## Hardy Road Properties

Final Drainage Report

PCD File No: SF265

February 2026

## EXISTING DRAINAGE MAP

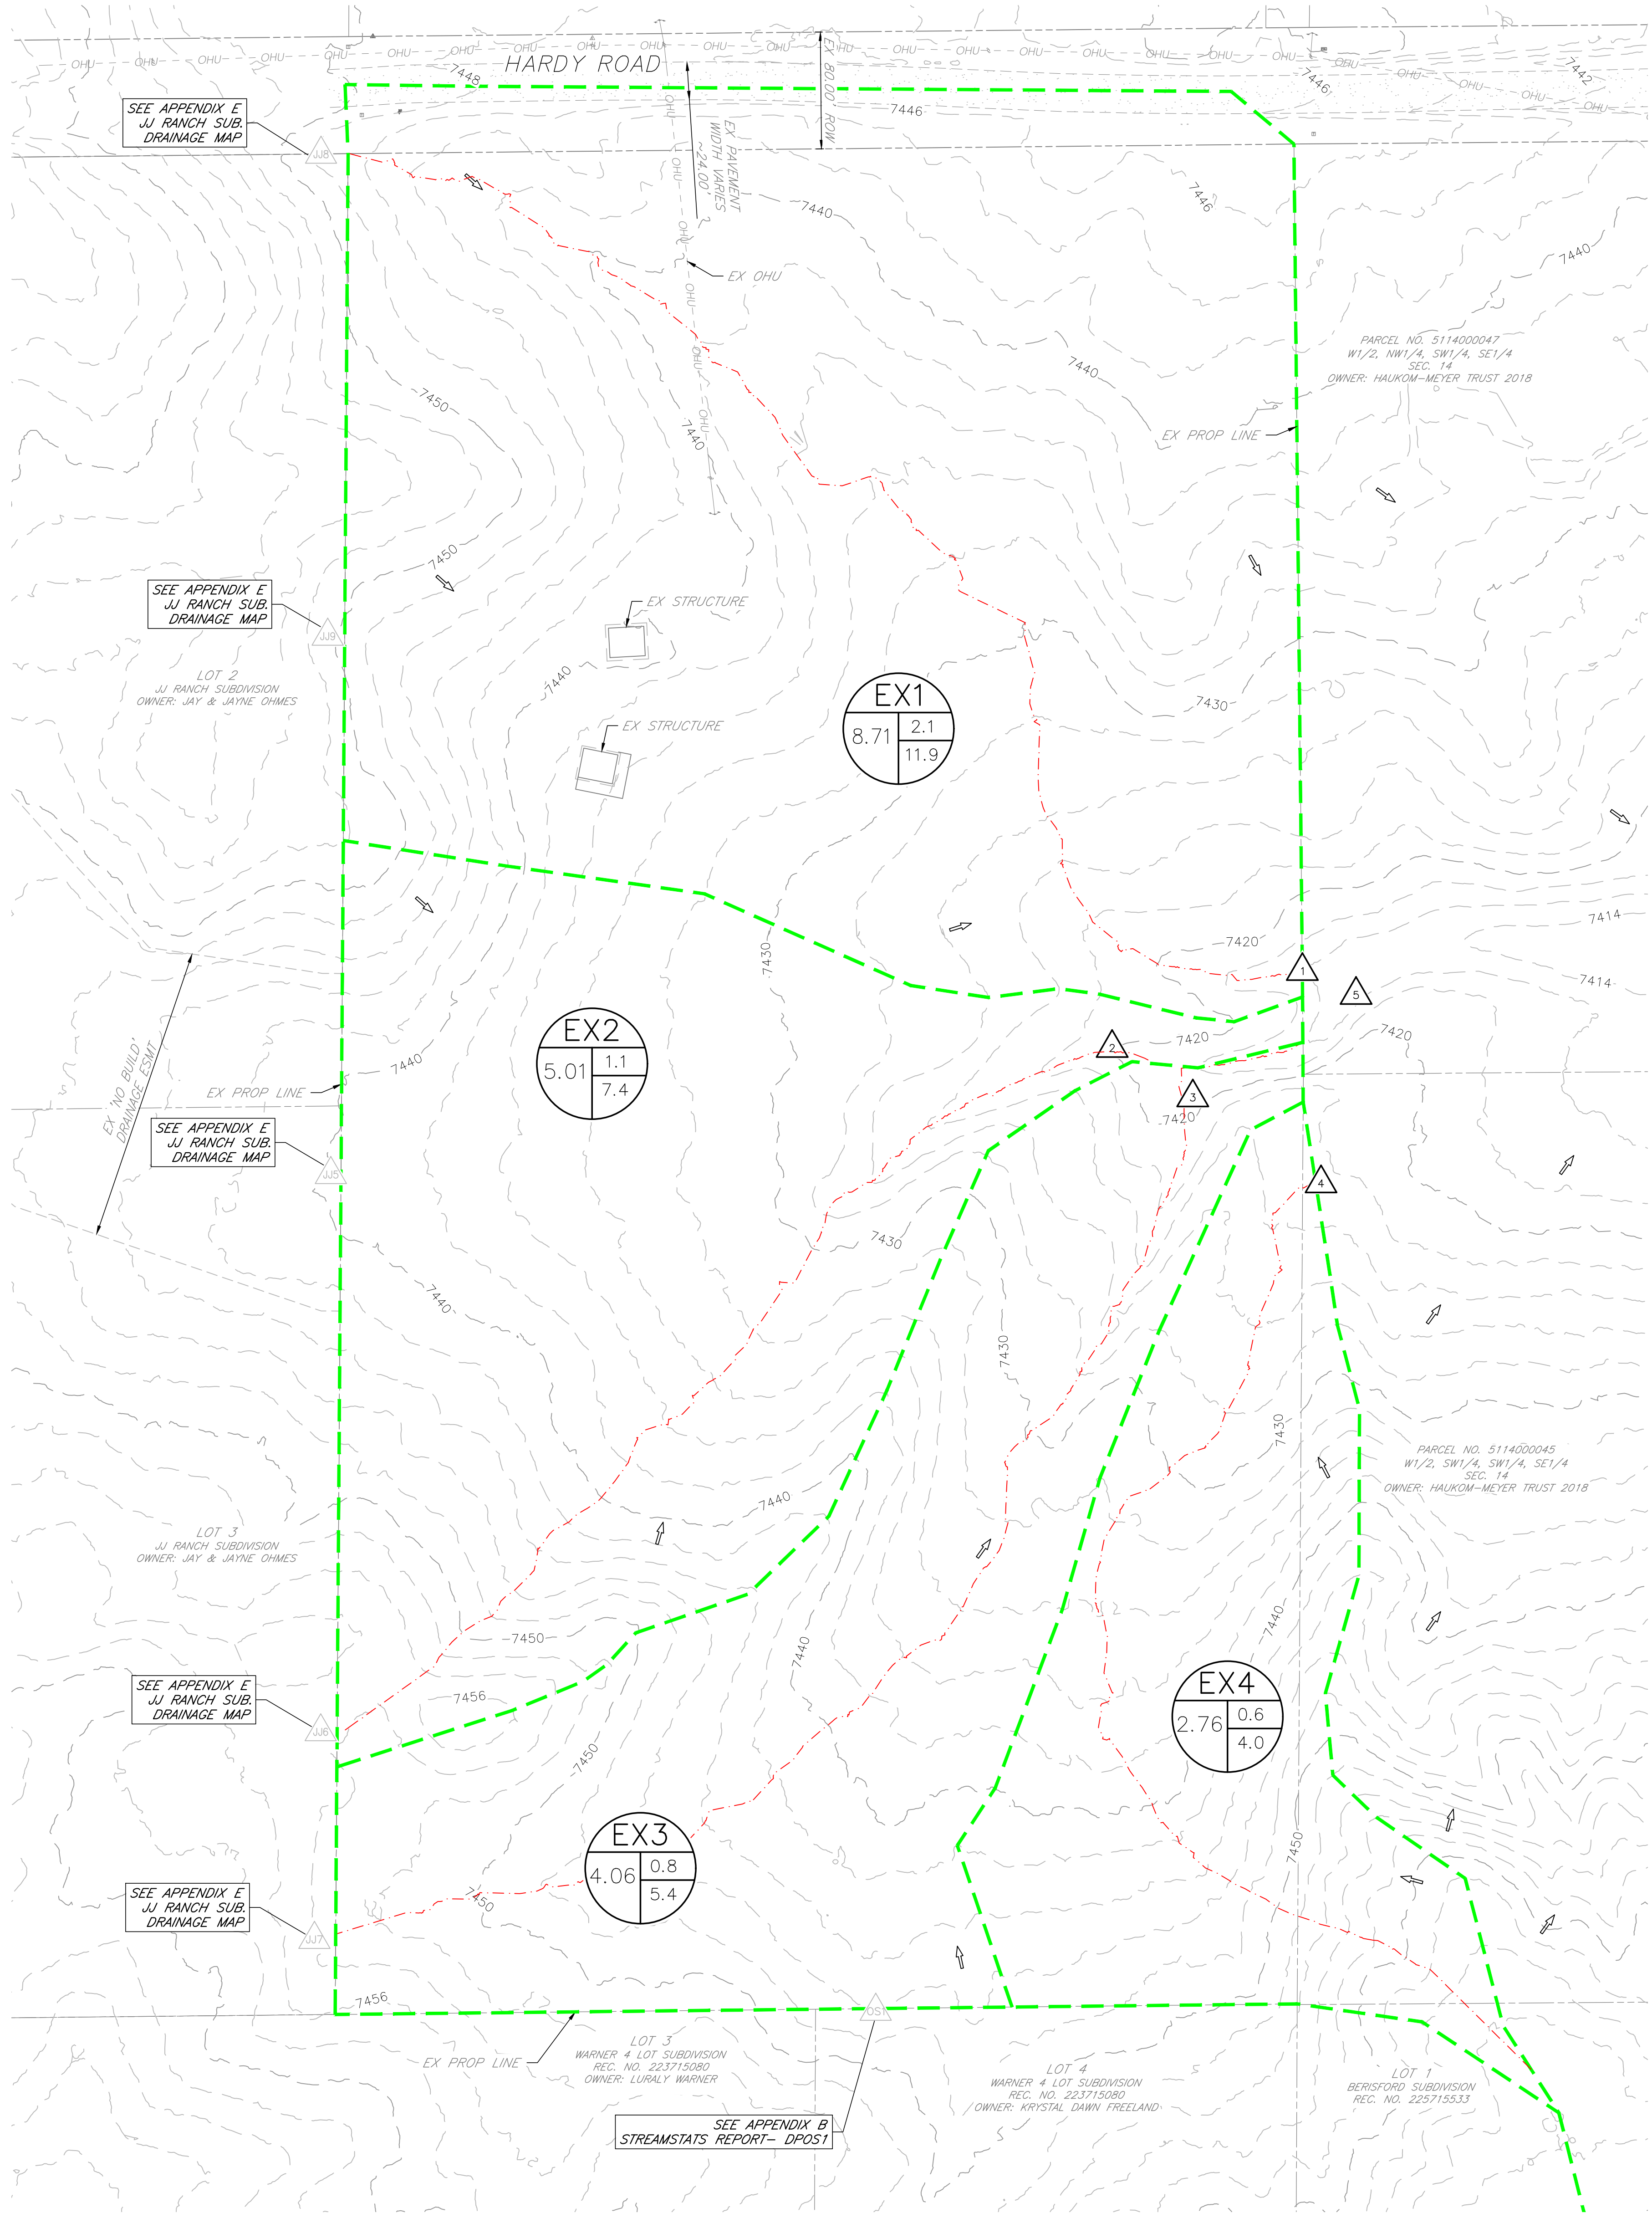
Explain in parenthesis, what are these two structures? I went to Google Earth and no structures are shown on this property, please include them on the location map and provide pictures for these structures and include the date of construction.

All Terrain: Refer to existing drainage map that shows the existing structures based upon field survey. The property is heavily forested and structures may not be visible from aerial.

- a. Photos of existing structures will not be provided. There is no requirement per the EPC FDR checklist to include photos of private structures. Furthermore, the date of construction is not required nor is known. Not addressed.
- b.

# HARDY ROAD PROPERTIES PROPOSED DRAINAGE MAP

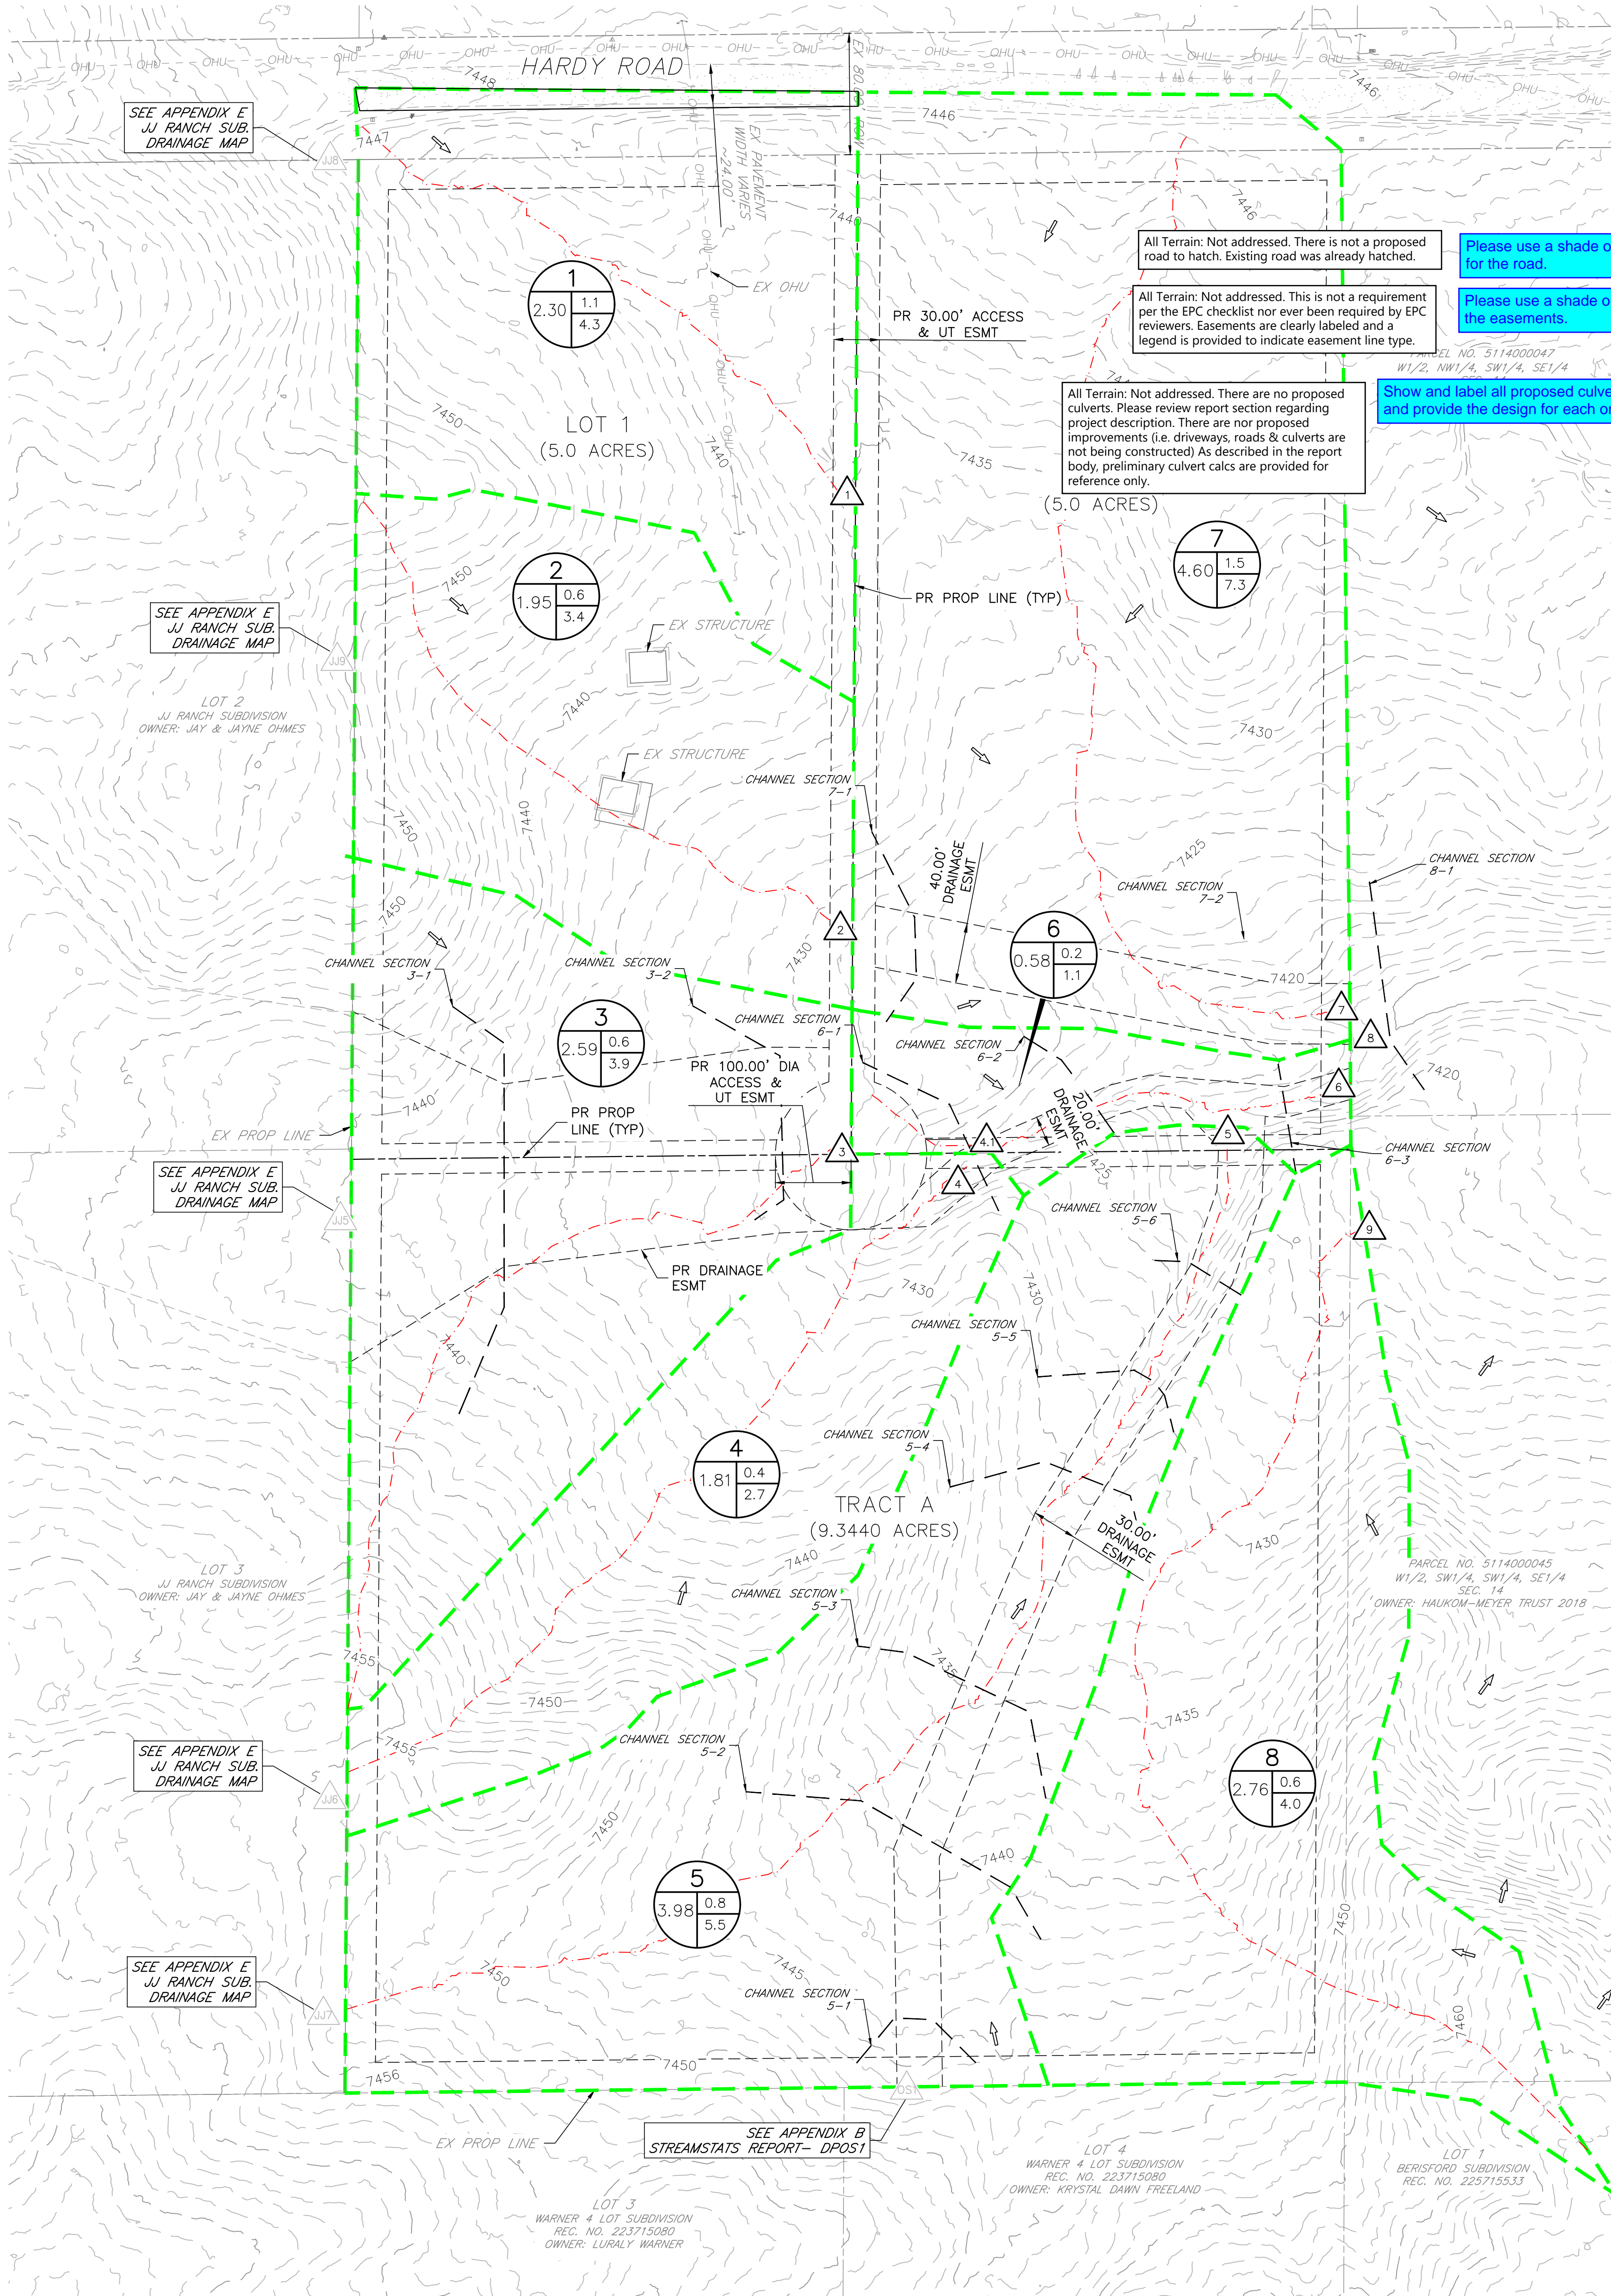
Please use a shade or crosshatch or color hatch for the road.

Show and label all proposed culverts (use a shade or cross hatch or color and provide the design for each one).

All Terrain: Not addressed. There is not a proposed road to hatch. Existing road was already hatched.
